Conceptual Review Agenda

Schedule for 05/05/14 to 05/05/14

Re: 1025 Buckingham St. - Light Industrial

Description of project: This is a request to construct a building to be leased for manufacturing, warehousing, distribution and other commercial and industrial operations at 1025 Buckingham St. (Parcel #9712116902). The parcel is currently vacant and the proposed building would be approximately 30000 square feet. The site is located in the Industrial (I) zone district and the project is subject to an administrative review (Type I Review).

SITE PLAN FOR LEMAY BUSINESS PARK

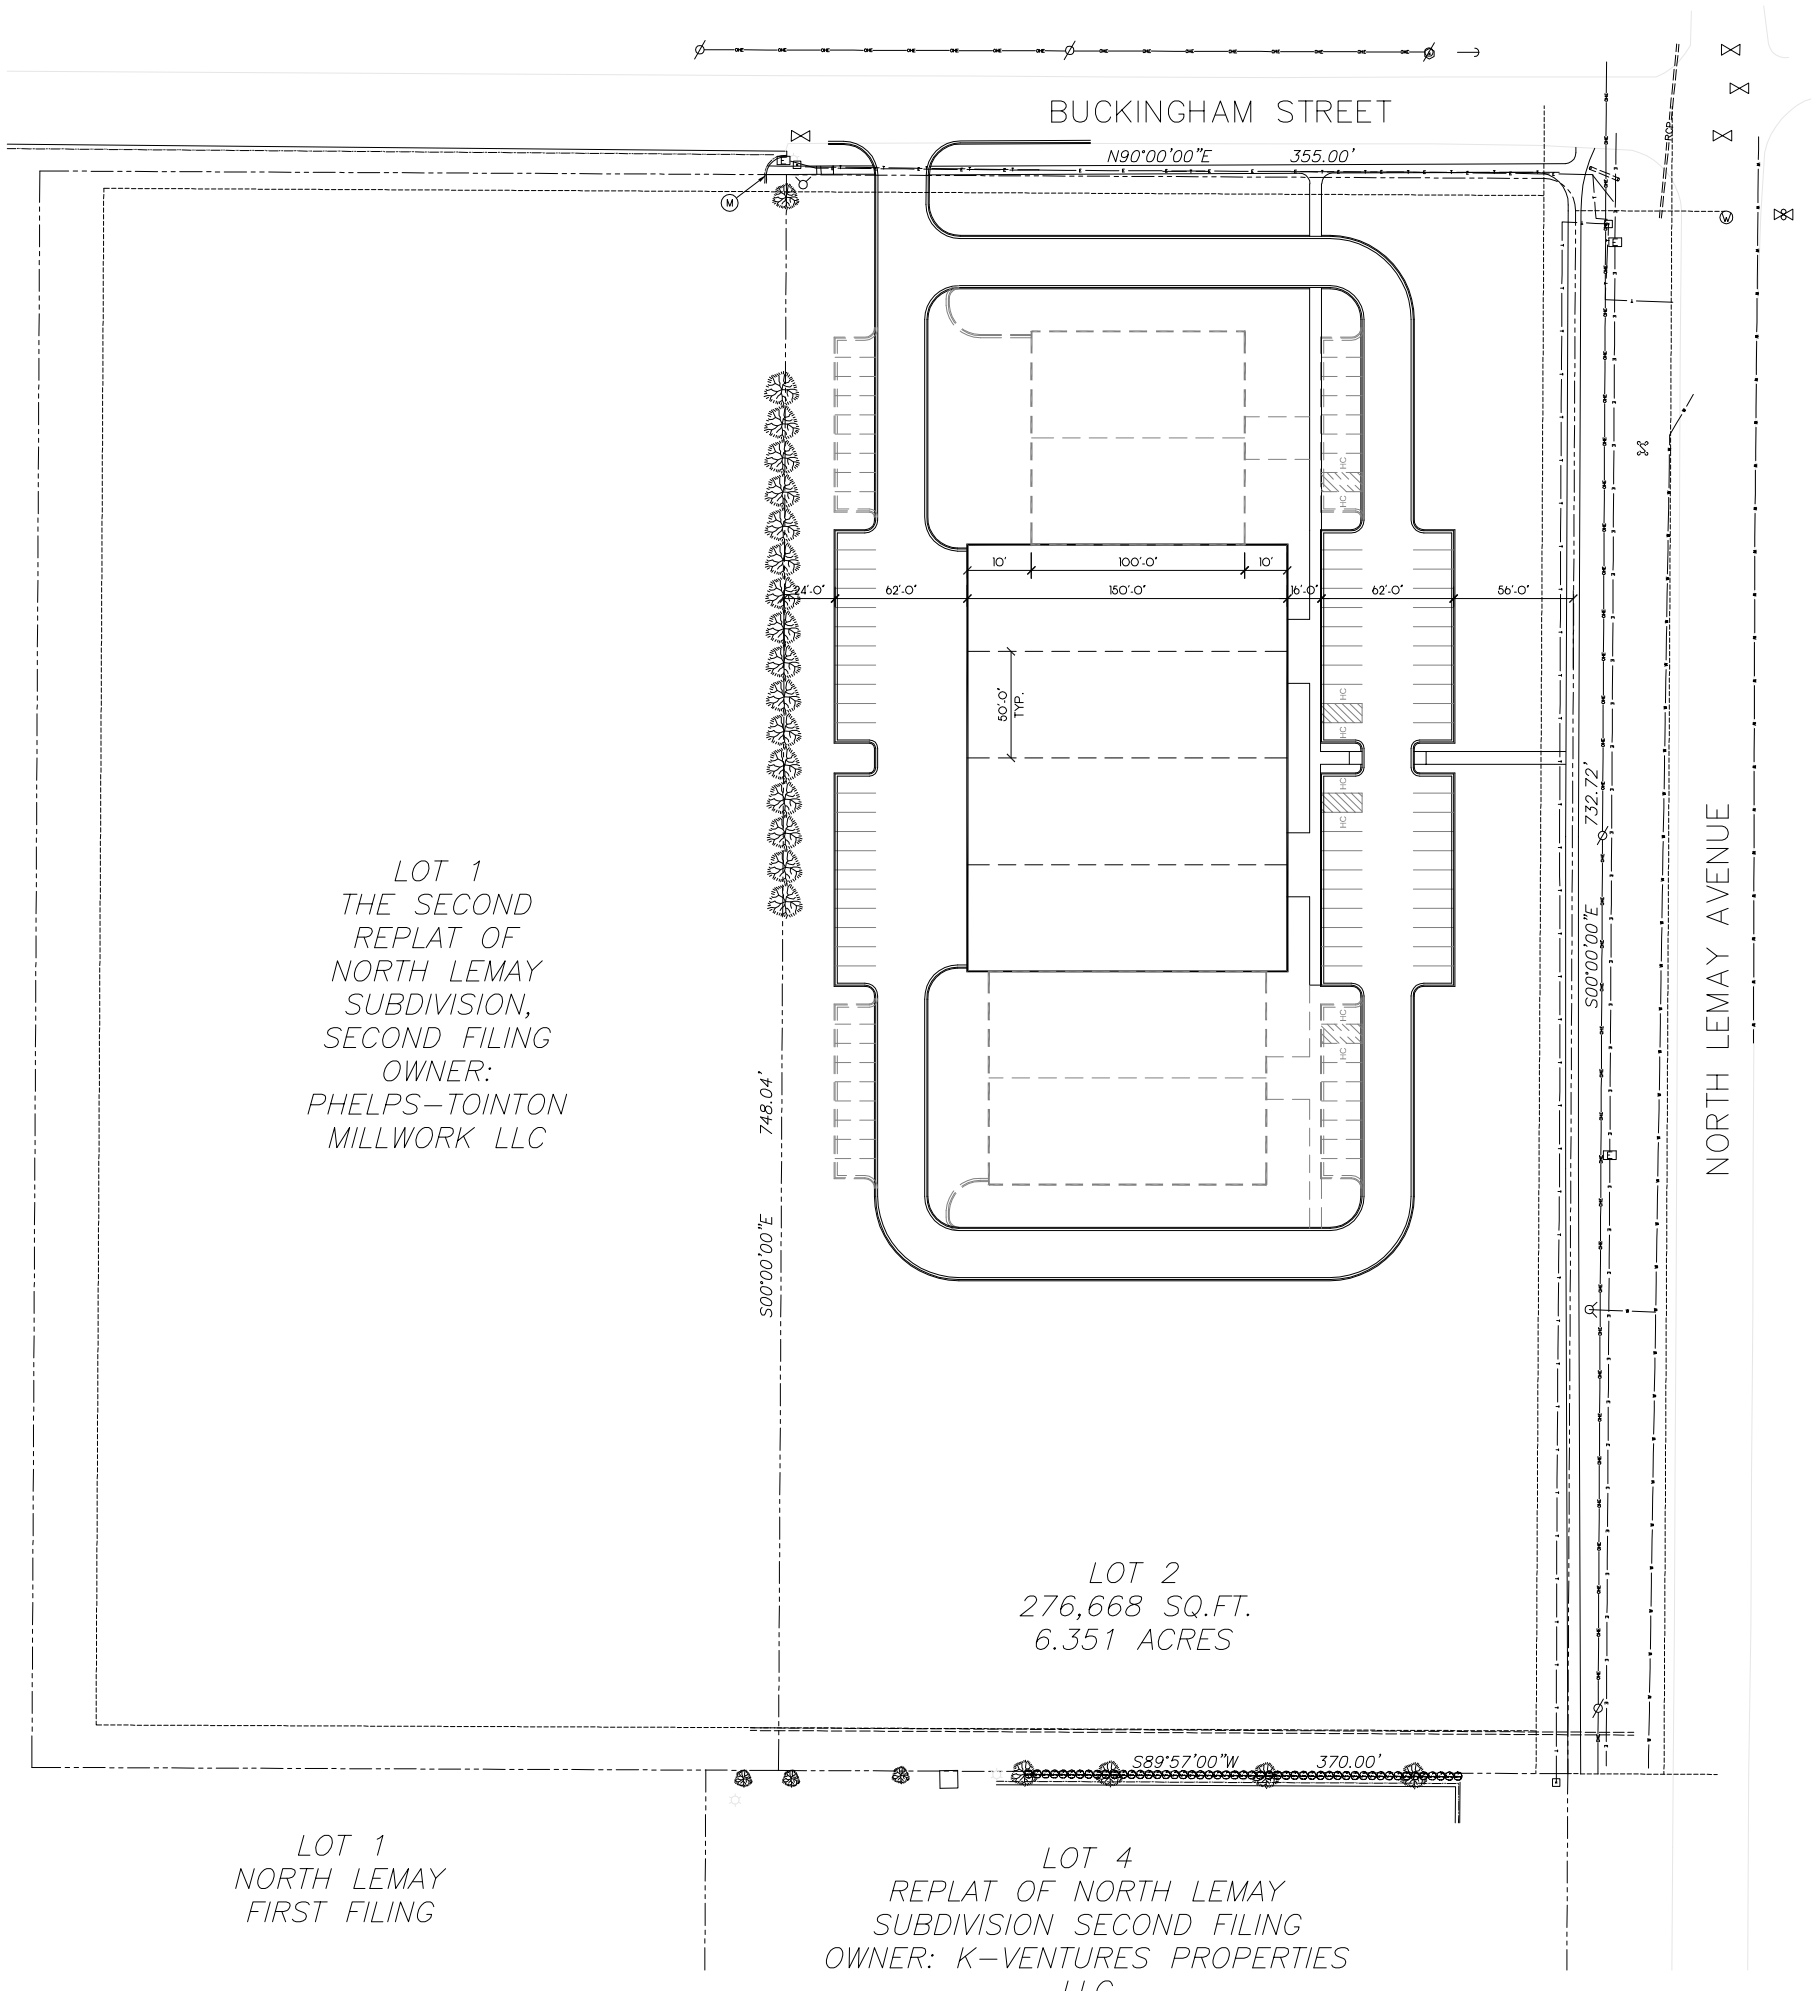
1. LUC 3.2.2(K)(2) Industrial/commercial uses are limited to a maximum number of parking spaces, to be determined by the final mix of uses planned for the site.
2. LUC 3.2.2(C)(4) A minimum of 4 bicycle parking spaces will be required; this number and the need for any enclosed bicycle parking spaces may change depending on the ultimate use mix.
3. LUC 4.28(D)(b) If the building is 50,000 sq.ft. or greater it will require Planning & Zoning Board (Type 2) review. Certain uses planned for the site may also trigger the need for Planning & Zoning Board (Type 2) review.
4. LUC 4.28(E)(3)(a) A 30 foot landscaped yard needs to be provided along Lemay Avenue and Buckingham Street.

LUC 4.28(E)(2)(b) A building face comprising at least 30% of the building frontage is needed along the landscape buffer yards along Lemay and Buckingham. This building face cannot be a blank wall.

Consider building towards the northeast corner and the intersection of Lemay/Buckingham to help satisfy the building orientation, landscape buffer and fire access requirements.

* Sample Sketch Plan

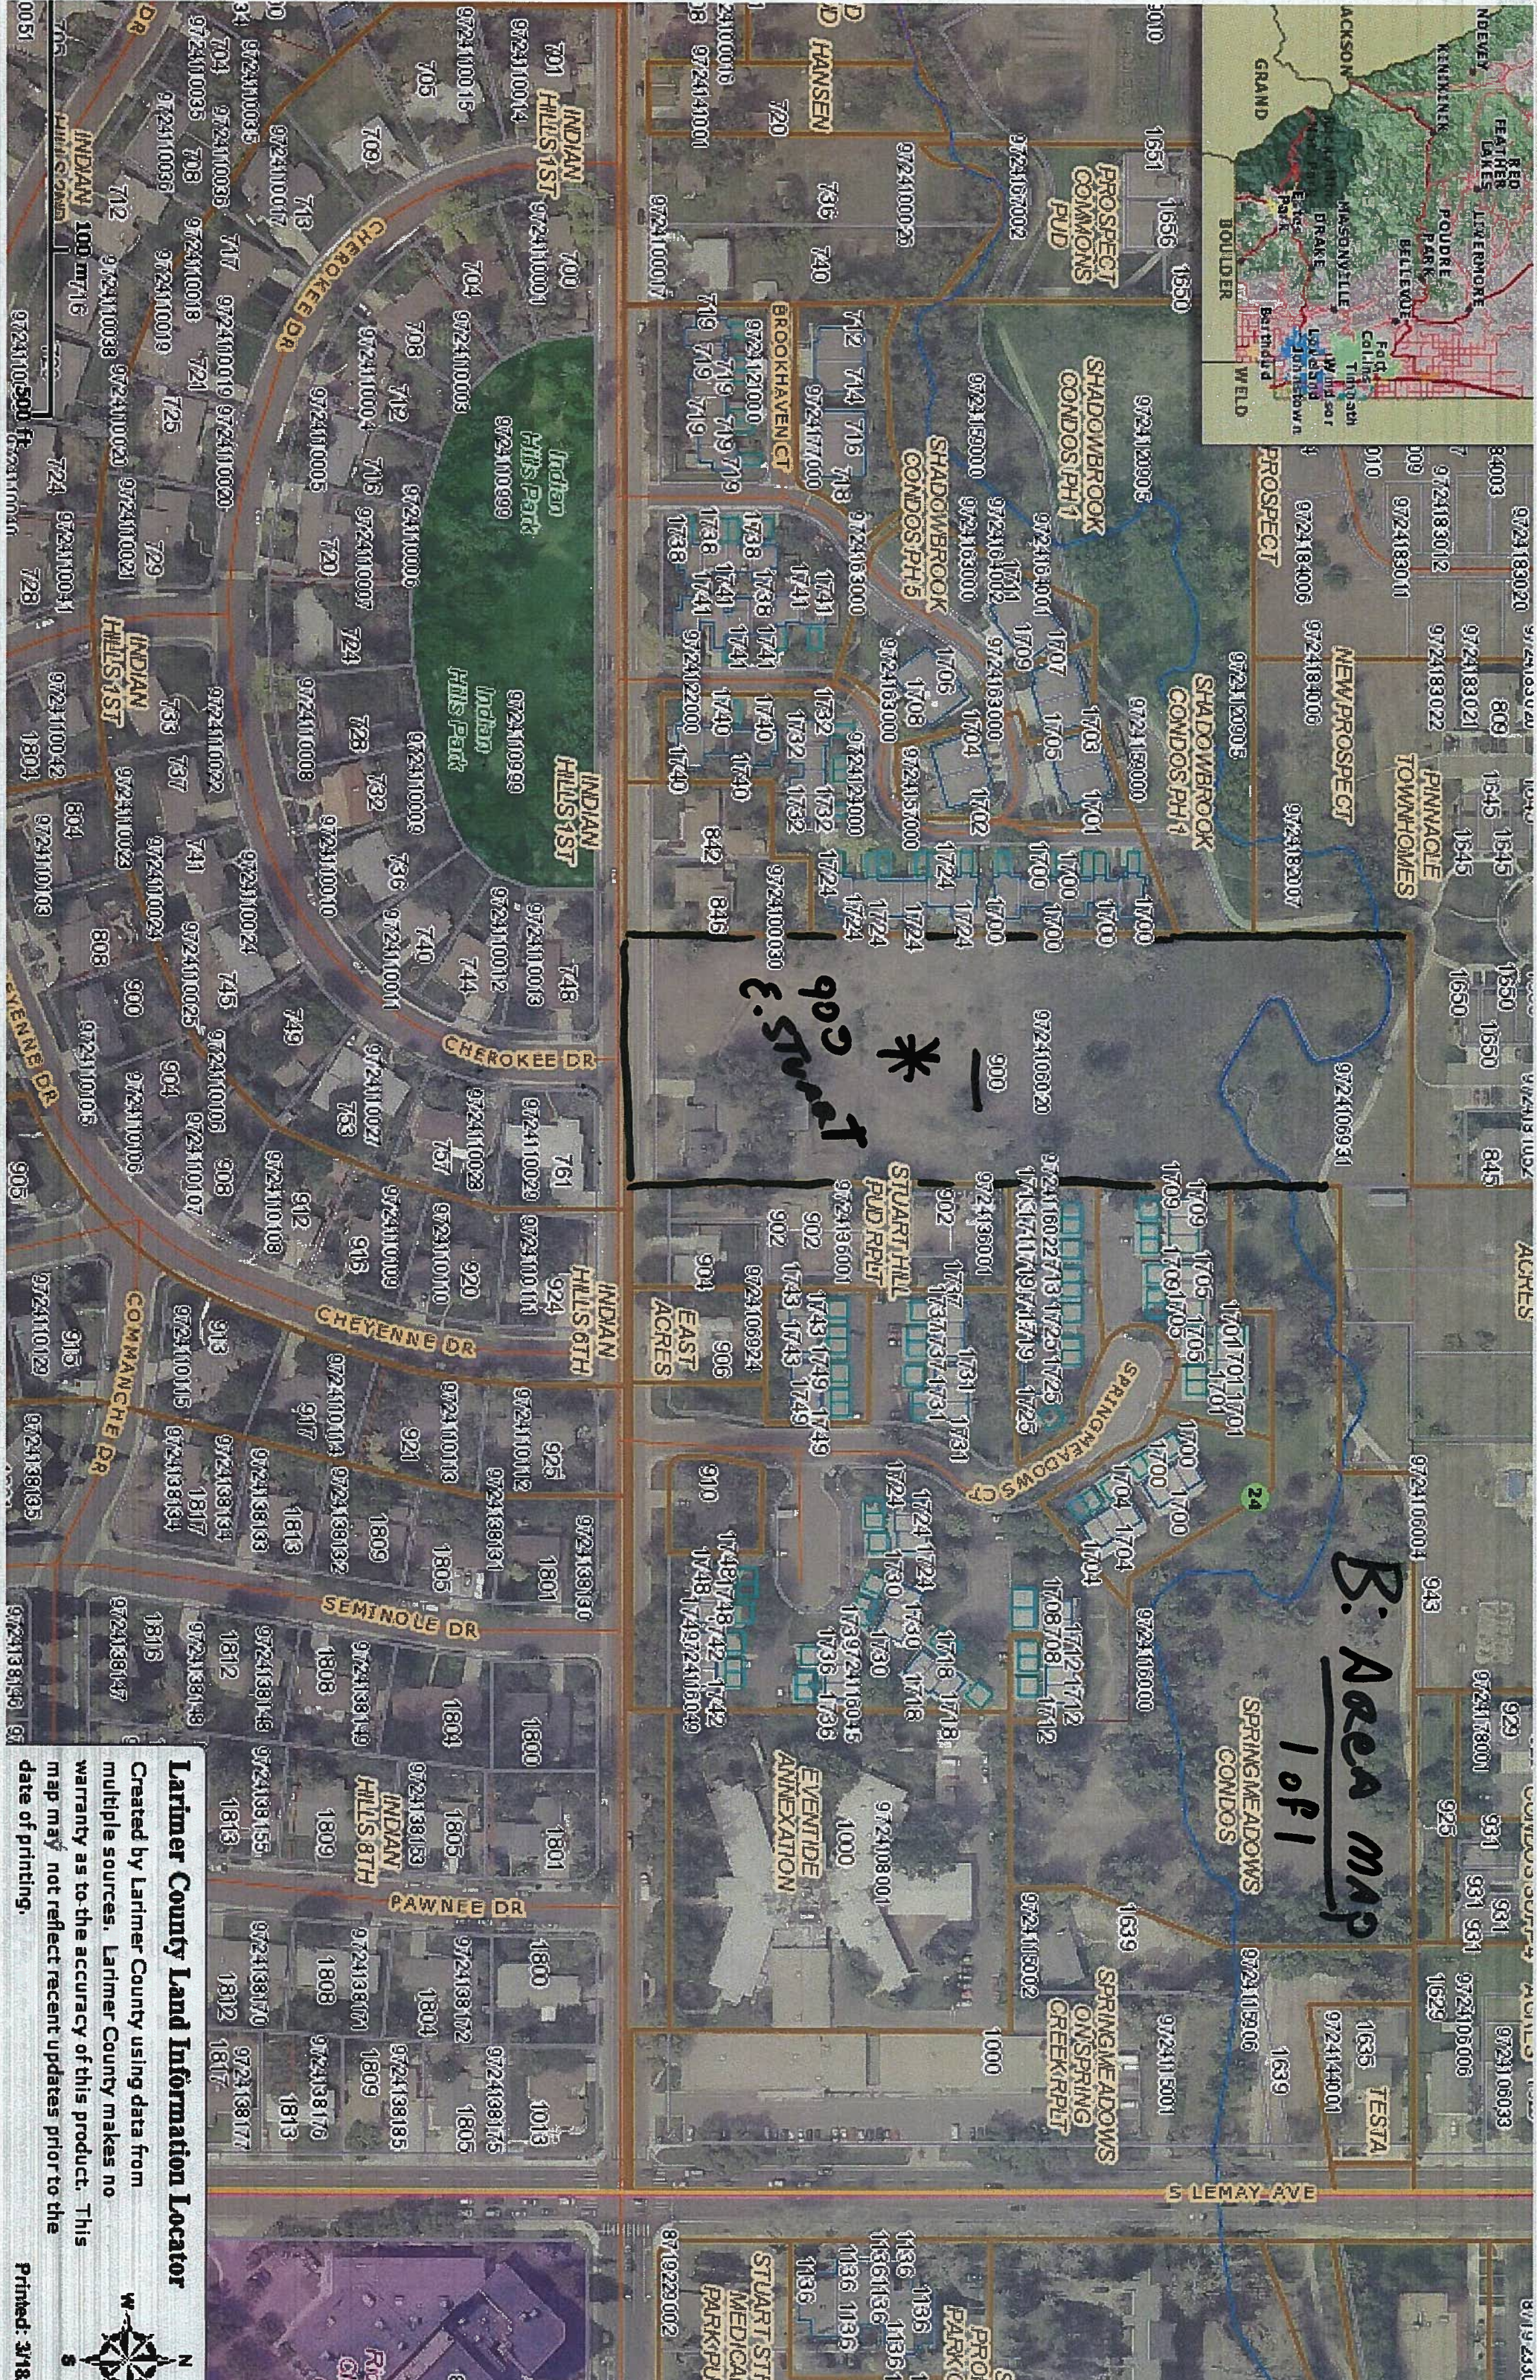
4. The Stuart Street frontage and any internal streets will require sidewalks and street trees.
5. Staff suggests that the applicant pursue acquiring a pedestrian access easement from the adjacent property to the west that will provide the ability to construct a hard-surface pedestrian trail connecting to the Spring Creek regional trail.
